## RESPONSE TO REQUEST FOR ADDITIONAL INFORMATION

### APR1400 Design Certification

**RAI No.:** 398-8457

**SRP Section:** 15.06.05 – Loss of Coolant Accidents Resulting From Spectrum of Postulated Piping Breaks Within the Reactor Coolant Pressure Boundary

Figure 1 Core flush by hot side injection

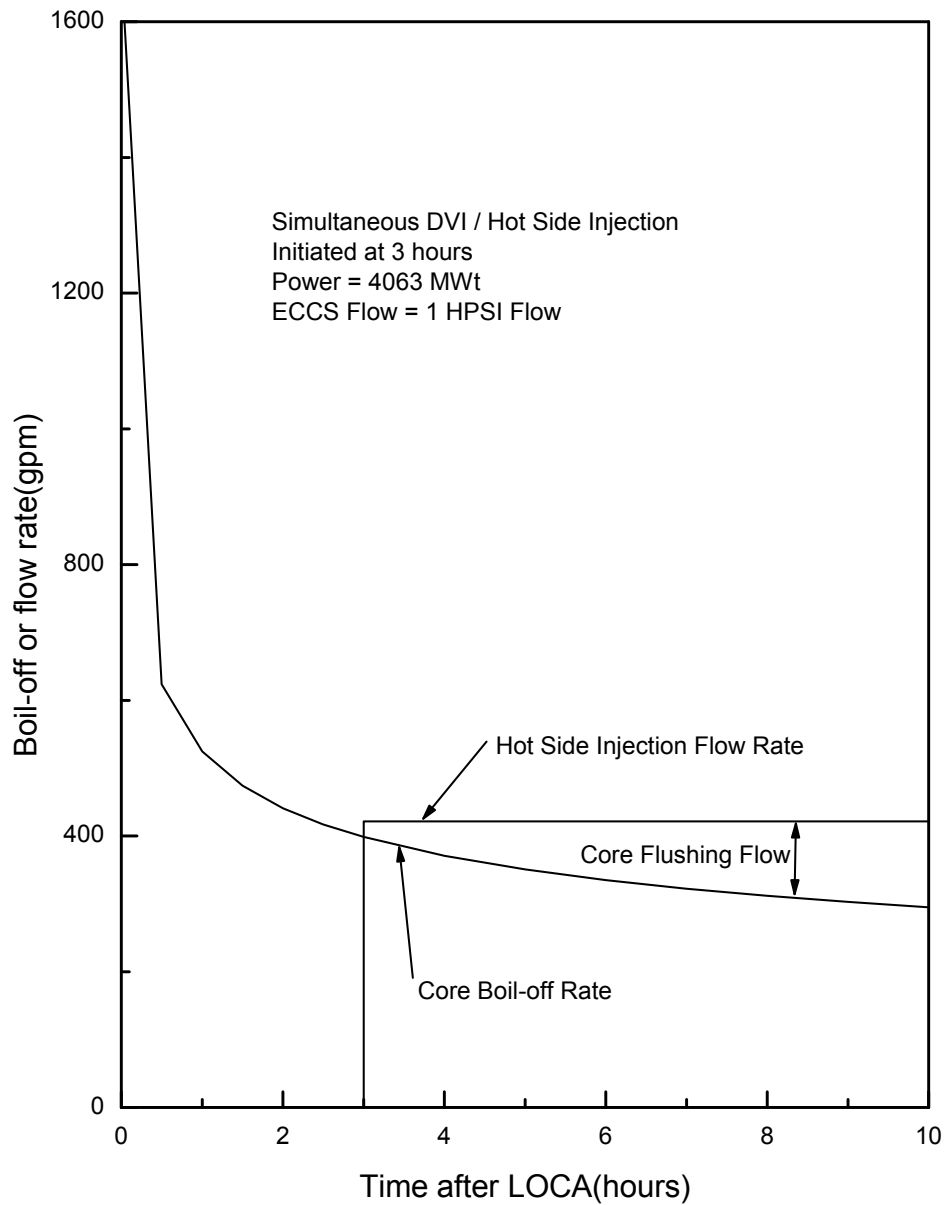
2. The analysis does not appear to account for reduced injection flow during the switchover to hot leg injection at 3 hours (Section 3.5.4). Is there a reduced flow during this transition period and how is it addressed in the calculation?

The injection flow is not considered to decrease during the switchover to hot leg injection. Instead, the injection flow is assumed conservatively. The flushing flow rate is calculated by hot side SI injection flow and core boil off rate as shown in Fig.1. Even though 2 SI pumps actuate during the switch over period, it is assumed that 4/10 of the total flow from a single SI pump enters the reactor vessel from the hot leg and all of the decay heat from the core boils off liquid. At 3 hours, core flushing flow is decreased to 23 gpm. After 3 hours, as the core boil off rate has decreased, the core flushing flow has increased. The flushing flow rate is used to compute the boric acid concentration in the core.

Figure 5. Inner Vessel Boric Acid Concentration vs. Time

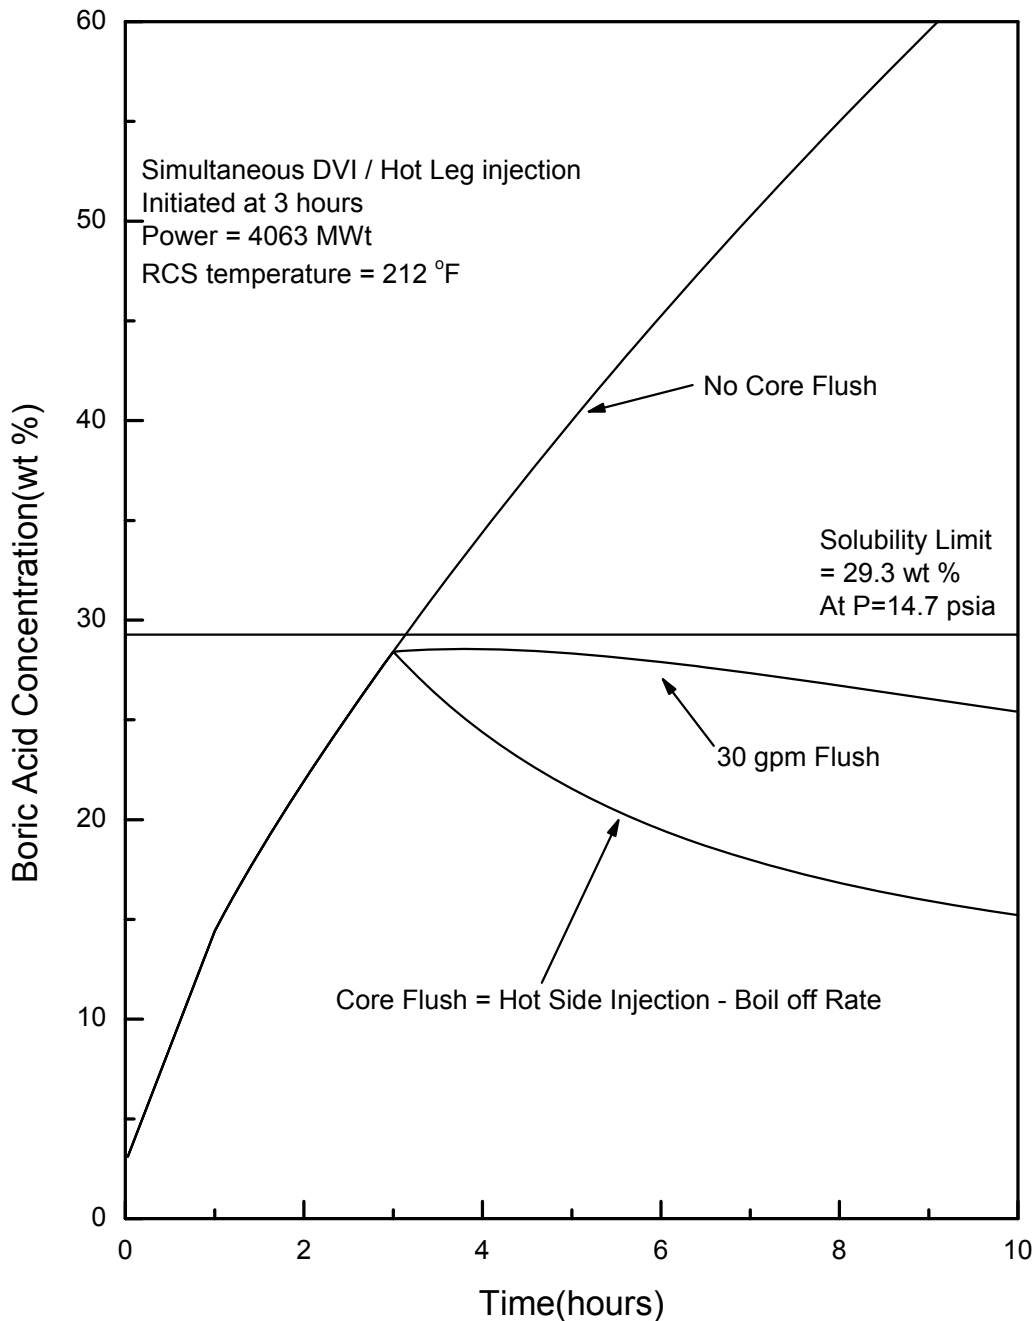
13. Figure 4-3 shows the buildup of boric acid concentration which depends on the boiloff rate and appears to be independent of break size? For smaller breaks where natural circulation is mixing the coolant, the switch to hot leg injection could possibly hinder the natural circulation by introducing cold liquid into the hot side of the natural circulation loop. How does the approach used address this possibility?

The double ended cold leg break size is the limiting break for long term boric acid accumulation in the inner vessel region, because the largest amount of coolant with high boron concentration is added to the inner vessel from SITs and SI pumps. Therefore, only the double ended cold leg break size is considered to calculate boric acid concentration by the BORON code. Thus, the boric acid concentration for the double ended cold leg break size is depicted in Figure5.

The mixing volume for computing the boric acid concentration is changed to include the additional volume from the top of the core to the top of the hot leg piping at the RV outlet nozzles. If the water level in the inner vessel is higher than the top of hot leg, boron precipitation is not a concern. Natural circulation is not considered in the BORON code because natural circulation begins when injected water refills to the top of the steam generators, in the case of smaller break sizes.

Even though the switch to hot leg injection could possibly hinder the natural circulation by cold water; boron precipitation does not occur around the top of the core. Thus natural circulation is not addressed in the BORON code.

Figure 6. RCS Pressure after Refill vs. Break Area

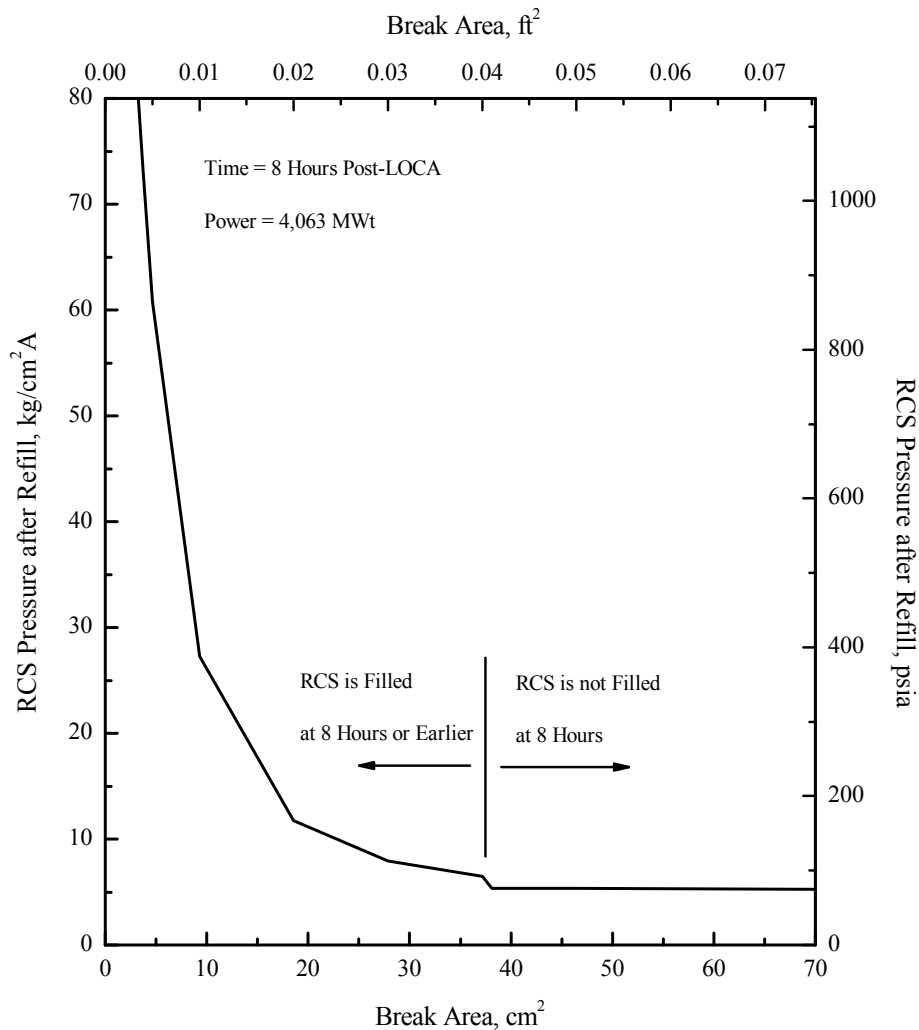
14. In the CENPD-254 methodology, the maximum break size for the small break analysis is determined by the auxiliary feedwater capacity. There is no mention of auxiliary feedwater capacity in the technical report. How was the upper limit size determined for the small break?

The decision time at which the operator decide whether to use the large break procedure or the small break procedure in order to continue the cooldown of the RCS. This time (8hr) is determined between the earliest time at which the SDC entry conditions can be achieved, and the latest time for which auxiliary feedwater can be assured to be available.

In order for the SDC system to be used to remove heat from the RCS, there must be sufficient liquid in the hot leg from which it takes suction. If RCS is refilled before the decision point time, the break case is assured of having sufficient coolant in the RCS to use the SDC system. Thus, the decision time determines the upper limit size of small break for which the SDC system can be used. This break size is 0.04 ft<sup>2</sup> as is shown in Figure 6 below.
